1977 Corvette: Service Bulletin: Anti-Theft Alarm Switch - Protective Grease

Bulletin No: 77-T-57

Date: Oct., 1977

FIGURE #1 - DOOR LOCK/ANTI-THEFT SWITCH INSTALLATION

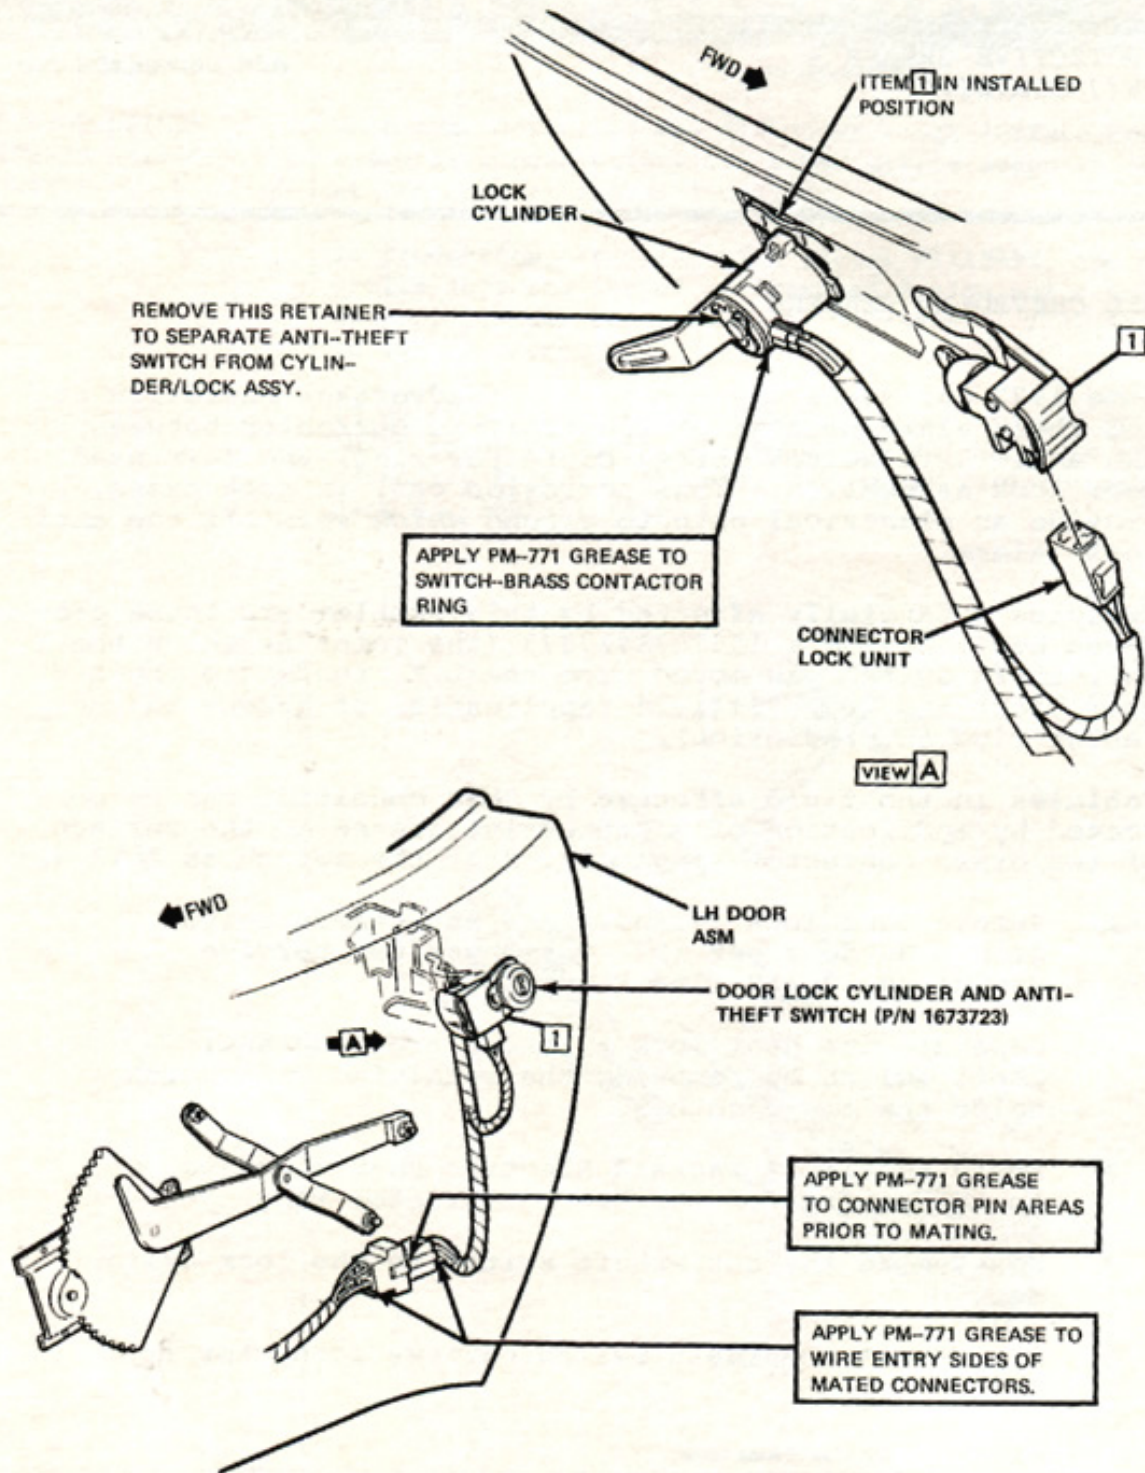
Some 1977 Corvettes may experience inadvertent operation of the theft alarm because of electrolytic corrosion between the anti-theft switch (brass contactor ring) and left hand door lock assemblies. This corrosion can, in some cases, provide an electrical path to ground which sets off the anti-theft alarm.

Vehicles potentially affected by this problem are those produced between VIN's 1Z37L7S427373 (the point at which the anti-theft switch was moved from the L.F. fender to the L.H. door lock) and 1Z37L7S441024 (application of grease to contactor ring in production).

1. Remove door lock cylinder and anti-theft switch from L.H. door per 1977 Passenger Car Service Manual pg. 2D-19 (See Figure 1).
2. Separate the door lock cylinder from the anti-theft switch by removing the retaining ring which holds the two together.
3. Apply a film of Packard Electric PM-771 grease to the surface of the

brass contactor ring.

4. Reassemble the anti-theft switch to the lock cylinder.
5. Disconnect the theft switch harness connector from the door wiring harness connector and apply the same grease to connector pin areas. Reassemble connectors and apply this grease to the wire entry sides of the mated connectors.
6. Reassemble the door lock cylinder and anti-theft switch to the L.H. door per Service Manual instructions.

A satisfactory substitute for Packard Electric PM-771 grease is GM P/N 1050109 or 1050110.
